Product Change Notification / SYST-18DKRG943

ERRATA - KSZ9131MNX Silicon Errata and Data Sheet Clarification

Silicon Errata and Data Sheet Clarification

FIGURE 1: TOP MARKING DATE CODE INDICATION

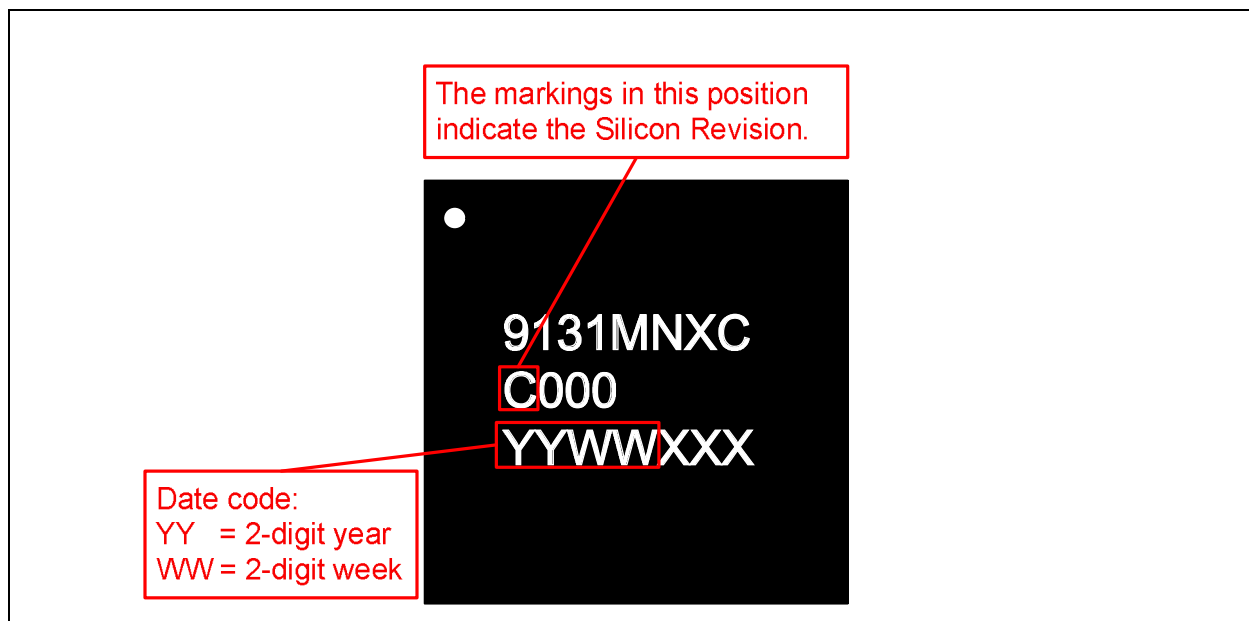
Description of Change: Changed the silicon revision marking from "C0" to "C."

Revision Level & Date	Section/Figure/Entry	Correction
DS80000997B (02-18-22)	Table 1 , Table 2 , and Figure 1	Changed the silicon revision marking from "C0" to "C."
DS80000997A (02-14-22)	All	Initial release
